SERVICE BULLETIN

VHF, UHF 30 WATT AMP POWER CONNECTOR FAILURE

BULLETIN NUMBER: SB-0006
REVISION: A
DATE: NOV 2003

PRODUCT DESCRIPTION: VHF, UHF 30 WATT AMPLIFIER

UT-30

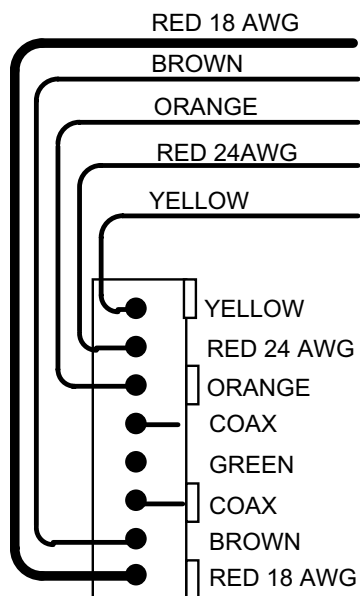
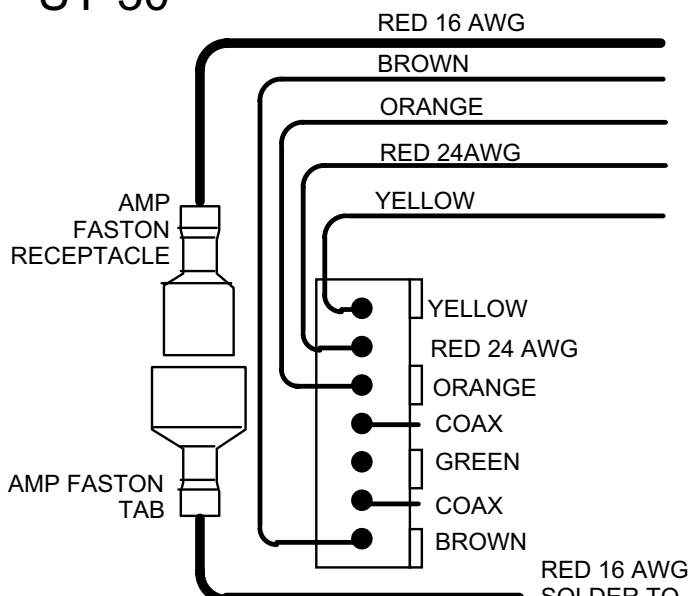
- 1) Replace the 8 pin housing (5022-156HS08L) with a 7 pin housing (5022-156HS07L).
- 2) Replace the 8 pin header (5022-156HD08L) on the sensor board with the 7 pin header (5022-156HD08L).
- 3) Replace Red wire for 13.8V power (between Sensor and power Switch) with two pieces of wire (7110-16S26302). Lengths of new wires are 10.5cm and 6.4cm. Crimp the AMP Faston Receptacle (5065-250R16A4) and the AMP Faston Tab (5065-250T16A4) to each piece of the 16AWG Red Wire.
- 4) The 16AWG wire can be soldered directly into the Sensor PCB header hole.

VT-30

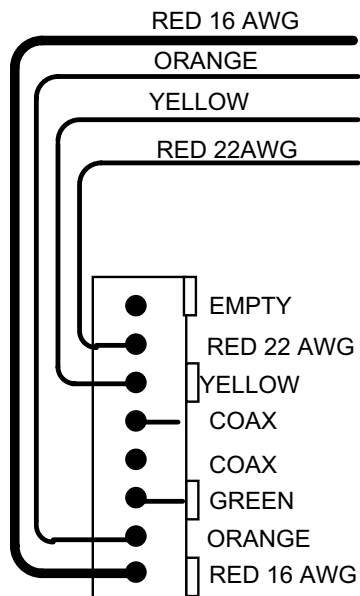
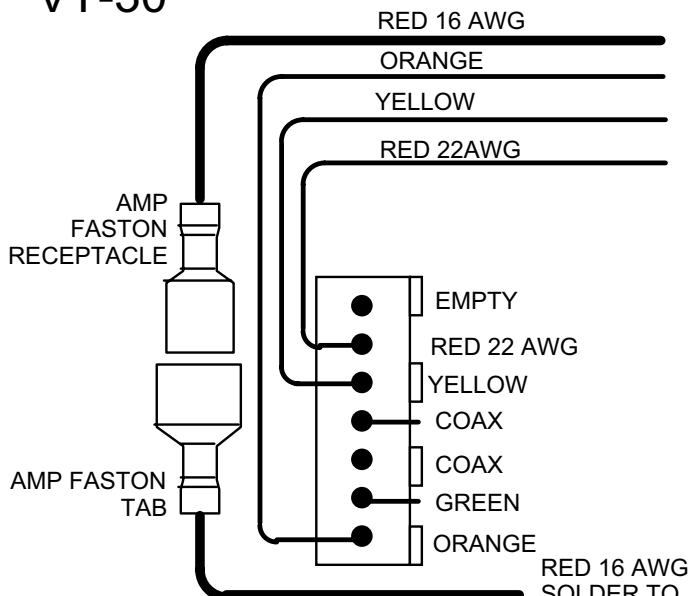
- 1) Replace the 8 pin housing (5022-156HS08L) with a 7 pin housing (5022-156HS07L).
- 2) Replace the 8 pin header (5022-156HD08L) on the sensor board with the 7 pin header (5022-156HD08L).
- 3) Replace Red wire for 13.8V power (between Sensor and power Switch) with two pieces of wire (7110-16S26302). Lengths of new wires are 10.5cm and 6.4cm. Crimp the AMP Faston Receptacle (5065-250R16A4) and the AMP Faston Tab (5065-250T16A4) to each piece of the 16AWG Red Wire.
- 4) The 16AWG will not fit into the original Sensor PCB header hole. The wire can be soldered directly to the Fuse Clip beside the header hole.
